East Hills Station Upgrade

Determination Report

Ref – 6549637

Status:	Final
Date of issue:	January 2021
Revision:	Rev C
Document author:	Michael Stojanoski
Document reviewers:	Belinda Crichton, Tracey Leotta, Mona Ren, Grace Cann, Natalie Moore, Ben Grogan, Justin Perrott, Ben Groth, Chiara Le-gerrard

Figure 3 Revised key features of the Proposed Activity (indicative only, subject to detailed design)

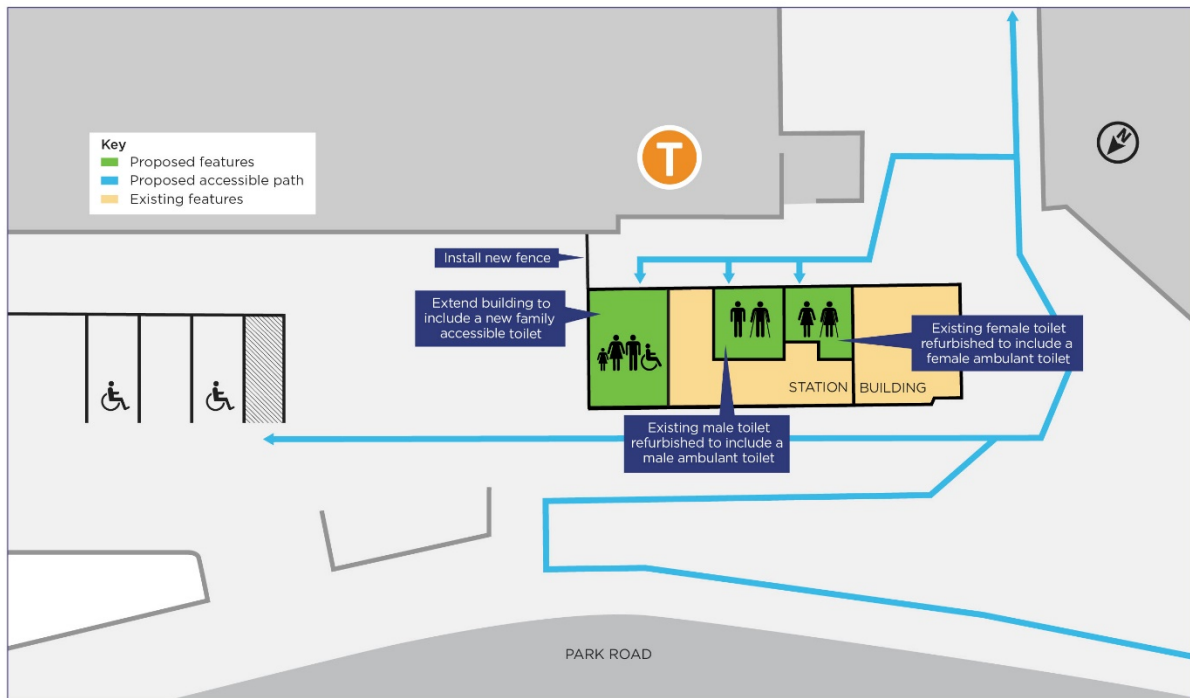
Further design development, along with consultation with the community and stakeholders, has resulted in a design change since the East Hills Station Upgrade REF was prepared. The change is outlined in Table 3, along with a discussion of the impacts. The proposed change is shown in Figure 3.

Aspect of the Proposed Activity	Design change	Discussion of impacts
Upgrade of toilet facilities	<p>Further design development has identified improvements to the proposed toilet facilities at East Hills Station.</p> <p>Transport for NSW has modified the design of the Proposed Activity as follows:</p> <ul style="list-style-type: none">• Extension of the existing station building to accommodate the new family accessible toilet• Refurbishment of the existing male toilet to include a male ambulant toilet (a total of two cubicles)• Refurbishment of the existing female toilet to include a female ambulant toilet (a total of two cubicles).	<p>Whilst the proposed design change would introduce some additional impacts, the change is generally consistent with the impacts discussed in the East Hills Station Upgrade REF. Key environmental impacts of the proposed change are discussed below.</p> <p>Traffic and transport</p> <p>During construction of the proposed design change there would be no additional disruptions to pedestrian and cyclist movements than those identified in the REF.</p> <p>During the operation of the Proposed Activity, there would be no change to the commuter car park along Park Road, including availability of parking spaces, as a result of the extension of the station building to accommodate the new family accessible toilet.</p> <p>Socio-economic</p> <p>The proposed design change allows for staged construction of the accessible toilets leading to reduced disruptions to passengers using the station amenities during construction.</p> <p>Following construction, the proposed design change would result in increased accessibility to the amenities at East Hills Station.</p> <p>Visual amenity</p> <p>As the construction activities described in the REF would impact a relatively large portion of the station precinct, the additional work required for the design change are not anticipated to cause additional visual impacts.</p> <p>The proposed building extension would increase the overall size of the station</p>

Aspect of the Proposed Activity	Design change	Discussion of impacts
		<p>building by about 10 square metres. The building extension would align with the existing station building on the toilet entry side and be a maximum of 3.5 metres by 4.5 metres (external dimensions).</p> <p>Provided the design of the building extension is compatible with the form and scale of the existing station building the proposed change would be considered to have a minor change to the visual amenity area (refer to CoA 39).</p> <p>Noise and vibration</p> <p>The proposed design change is located in a similar position and would use similar equipment to the other accessibility upgrade work assessed in the REF. As such, the predicted noise levels during construction at nearby receivers would be similar to those presented in the REF.</p> <p>Construction work for the design change would be restricted to daytime hours.</p> <p>Biodiversity</p> <p>No vegetation clearing would be required to accommodate the design change.</p> <p>Waste</p> <p>During construction of the building extension additional small quantities of demolition waste would be generated from removal of the existing fence and building tie in work.</p> <p>During construction there would be no change in the amount or type of waste generated.</p>
